Marked up claims and specification for response to the office action mailed on April 23, 2002.

Serial No. 09/772,177

For WEB TRACKING ADJUSTMENT DEVICE AND METHOD THROUGH  
USE OF A BIASED GIMBAL

Marked up drawings for response to the office action mailed on April 23, 2002.

FIG-3

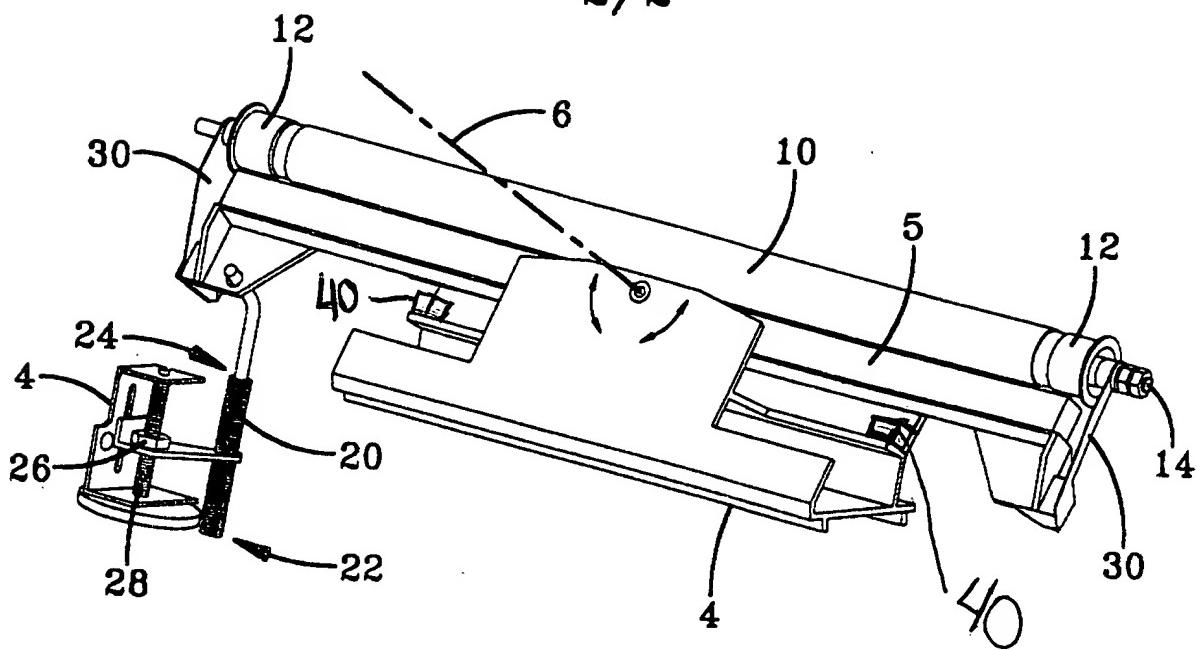
The drawings are objected to under 37 CFR 1.83(a), as the drawings must show every feature of the invention specified in the claims. Examiner states that the stopping means (see claim 16) must be shown, or the feature cancelled from the claims. The drawings are amended herein to include a stop **40**. Applicants respectfully submit that as amended the drawings are in more proper form, in compliance with the examiner's request.

According to a further aspect of the invention, a stop 40 is used for preventing the steering roller 10 from rotating too far in the gimbal direction.

FIG-4

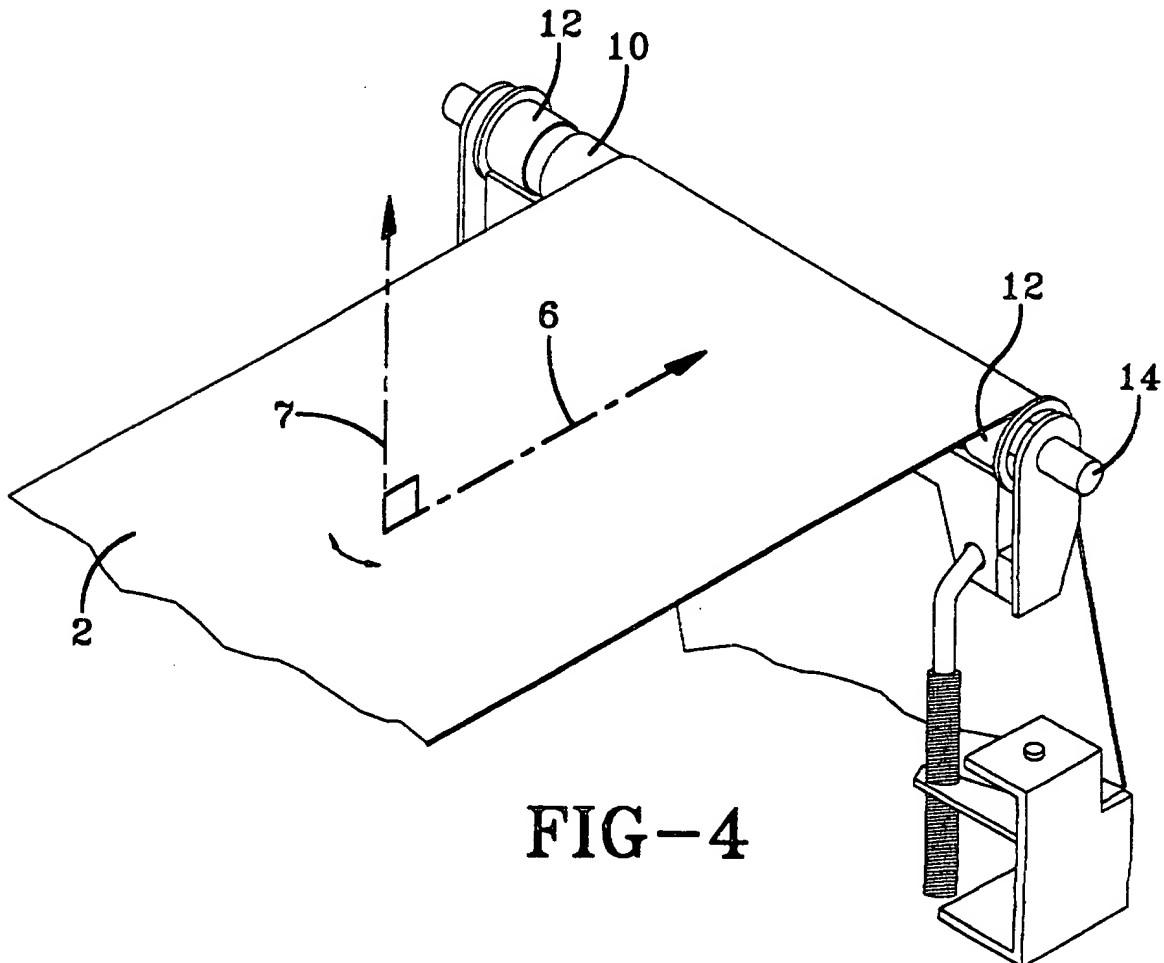
Regarding claims 7, 8, 10, and 20, the Examiner asks “what is a caster axis?” Referring to the specification page 3 lines 23-25 “a caster axis 7, which is

an axis perpendicular to the gimbal axis, which intersects the gimbal axis 6 upstream of the roller." Further, Figure 4 shows a caster axis 7. For the purposes of examination, the examiner has assumed that "the caster axis is perpendicular to the gimbal axis." Reference to the specification shows that the caster axis is indeed perpendicular to the gimbal axis, AND it intersects the gimbal axis upstream of the roller. Applicants respectfully submit that rejection of claims 7, 8, 10, and 20, and the claims which depend from them, on this basis is in error, and request that the rejection on this basis be withdrawn.
